**SOUTH GRAND CHENIER
HYDROLOGIC RESTORATION PROJECT
(ME-20)**

**FINAL ENGINEERING
DESIGN REPORT**

Response to EPA's South Grand Chenier Hydrologic Restoration Project (ME-20) 30% Design Review Comments

Response to the Corps of Engineers' South Grand Chenier Hydrologic Restoration Project (ME-20) 30% Design Review Comments

Figure 1: South Grand Chenier Hydrologic Restoration Project Conceptual Features.

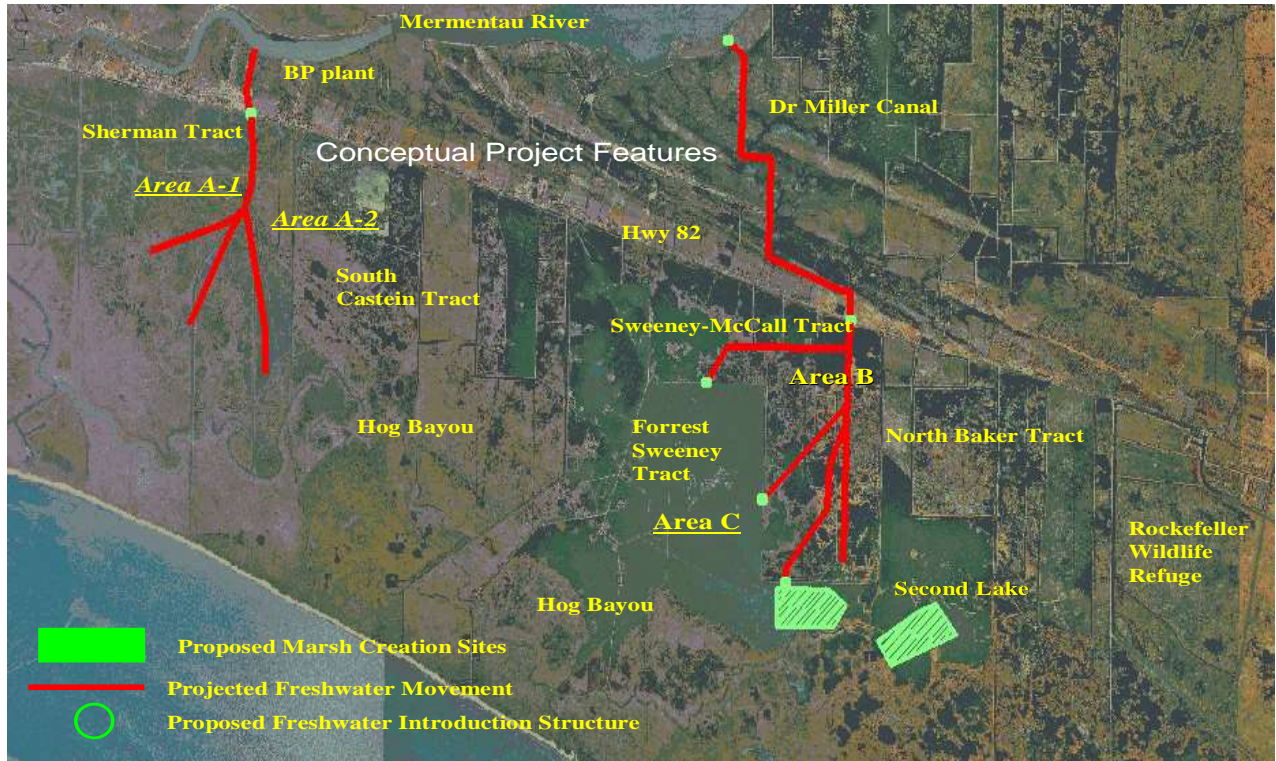
- Corps' Comment - The description of project features on page 2 is very confusing and Fig. 1 doesn't help much.

- Corps’ Comment - Table 1, Structures, bullet 6 – identify board roads, Miller-McCall levee and areas B and C on a plate. Show location of the four 1,200 culverts mentioned in the first full paragraph. Are the 1,275 foot long culverts mentioned in the second paragraph the same ones?

We do not understand the difficulty in interpreting Figure 1. That figure presents the project’s conceptual features, but not in a detailed manner. It shows two freshwater introduction features, the Dr. Miller Canal (east) and the BP Plant (west) plus the two marsh restoration (creation) cells to the south. Conceptual maps are not meant to show all depths, elevations and structures. The Figure 1 legend refers to its features. The preferred alternative map (Figure 3, page 6) is the official CWPPRA project features map found in the fact sheet (www.lacoast.gov). The Preliminary Drawings contain more project feature details.

Response – Areas B and C are depicted on Figure 1 (page 3) of the Report. Figure 1 also shows the board roads in the McCall Tract and the Miller-McCall levee, but they are not labeled. We will label the board roads and levee in Figure 1 of the final report. The board roads and Miller-McCall levee are depicted on Sheets 4 and 5 of the Preliminary Drawings.

Figure 3: Salinity Contour Maps for the Various South Grand Chenier Project Modeled Alternatives.

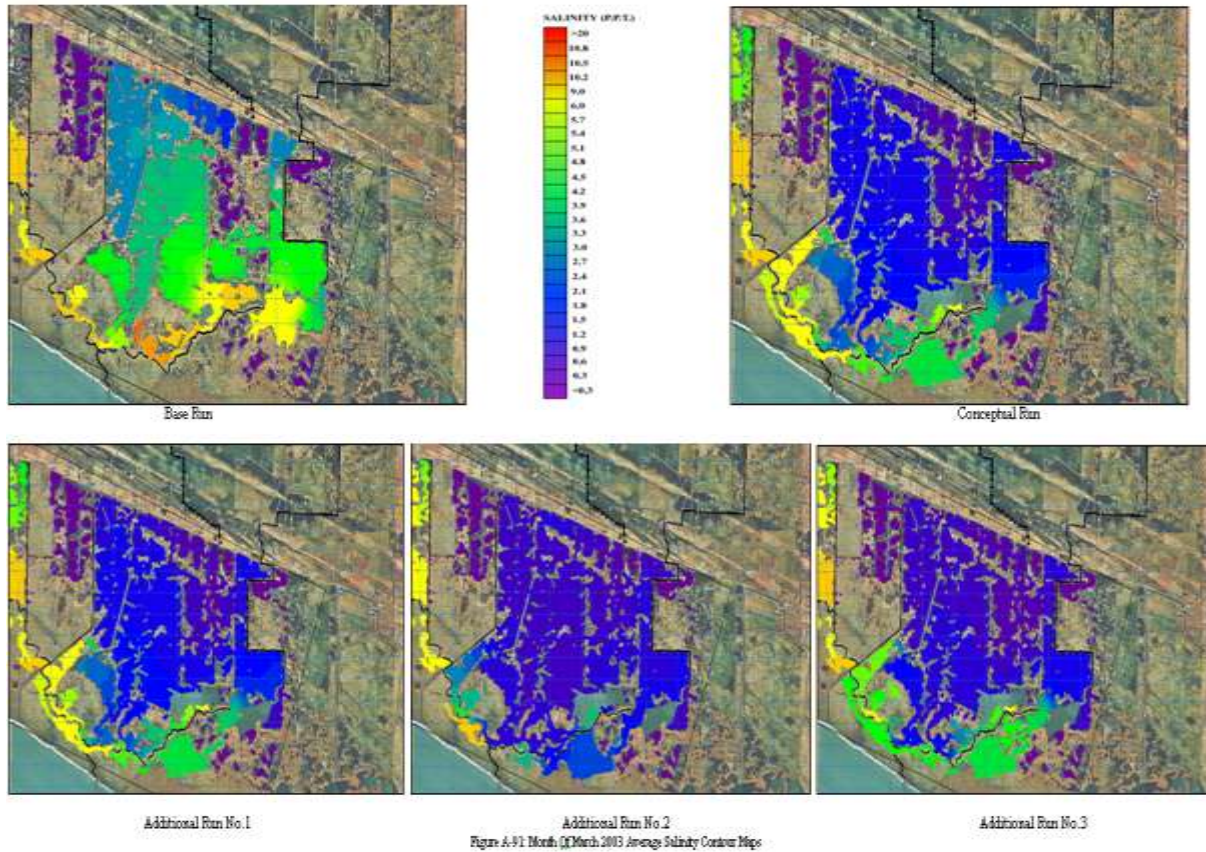
- Corps' Comment - Bullet 3 – Figure 10 shows much of the project area being brackish, with some fresh and some saline. In average of 5ppt seems very low for such an area. The project makes it nearly all fresh with an average of 2ppt. This seems high for fresh. To put it another way, the base run shows an area that is about 75 % intermediate, brackish and saline. Run #3 makes it 80% fresh. I have trouble seeing how a change from an average of 5 ppt to 2 ppt can freshen it this much, especially using Chabreck's salinity ranges:

- Corps' Comment - Fig 10 has some purple (fresh) in the far southeastern area – I assume this is due to Little Pecan.

Response – The fresh, intermediate, brackish, and saline indicators in Figure 10 refer to water salinity levels not marsh types. The figure will be revised to either remove the labels or identify them as referring to water salinity levels not marsh types. Thus the “fresh” indicator means that water salinities are on the fresh side, not that the marsh is fresh. However, if salinities consistently remained below 2 ppt within project marshes, this “fresh” area would convert from brackish and intermediate to fresher marsh types.

Response – The modeled effects of the South Grand Chenier Project alone, not Little Pecan, are depicted in Figure 10. The area referred to in “purple” is the Baker Tract east of Area B. Area B (Sweeney-McCall tract) has openings in its eastern levee that allows freshwater to freshen the adjacent Baker Tract north of Second Lake.

Figure 5: Area A (BP Plant) Salinity Contour Map for March 2003 Modeled Runs.

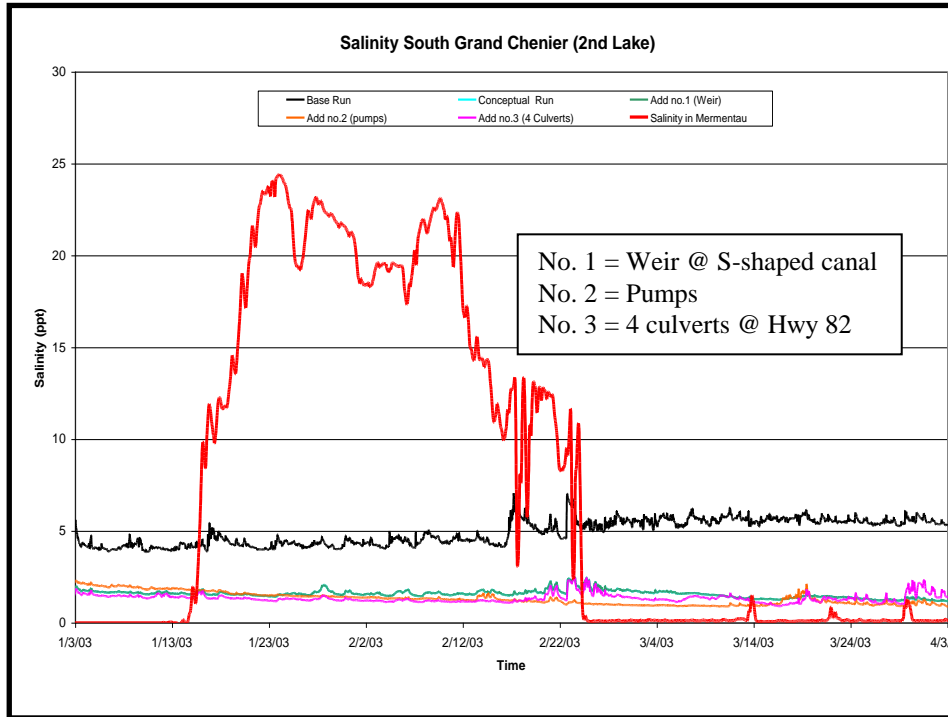
- Corps' Comment - Fig 13, Run 4 – since the BP project area is totally separate from the Dr. Miller area, how can 4 culverts change anything from the base run? It seems to change brackish marsh to saline.

Response – The BP Plant feature was changed from 2, 48 inch to 4, 48 inch-diameter culverts, doubling its diversion capacity, for the 4-culvert model run. That model run also increased the Dr. Miller Canal Hwy 82 culverts from 2 to 4, 48 inch-diameter culverts. Therefore the total diversion capacity was increased 100% at both diversion locations.

You are correct that the model predicts that the BP feature would increase salinity in the target marshes at least for part of the modeled period. This is one reason the BP Plant diversion feature was removed from consideration. The other reason was that the BP feature did not reduce salinities.
